Addendum to IFB

IFB TITLE: Crime Lab Vehicle Search/Investigation Building Renovation

ADDENDUM NO.: 1

ADDENDUM № 1

DATE 3-11-24	DRAWN BY: ANM	APPV'D BY: SJE	SCALE 1/4" = 1'-0"	JOB NUMBER JCVB-23/154079
JEFFERSON COUNTY VEHICLE SEARCH/INVESTIGATION BUILDING BEAUMONT, TX COLD WATER REVISIONS				SHEET NO. CS02

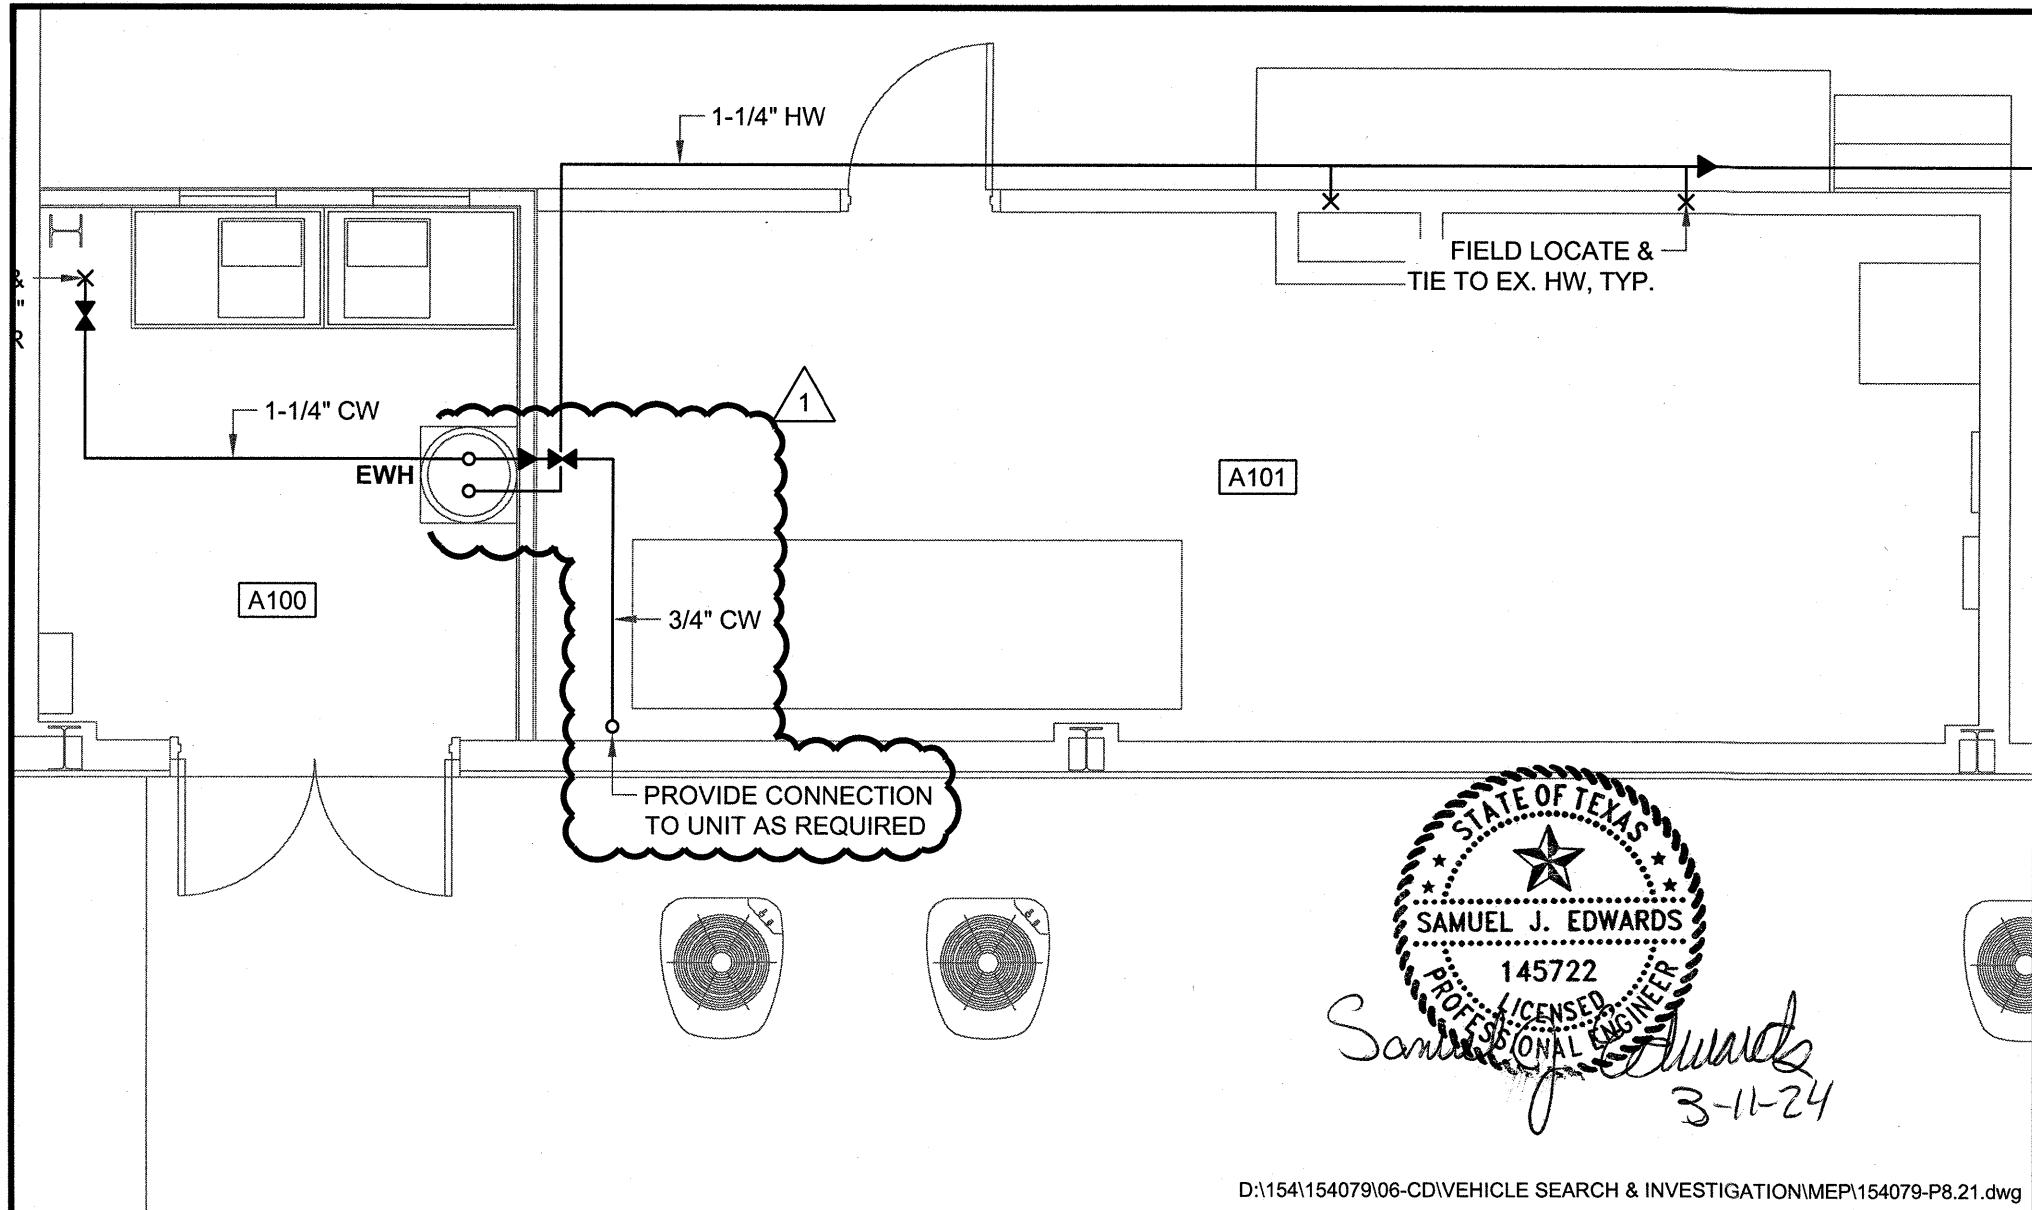
1. See attached Architectural drawings A0.2, A1.0, and A1.1.
2. See attached Civil sheets CS01, CS02, CS03, CS04 and CS05.
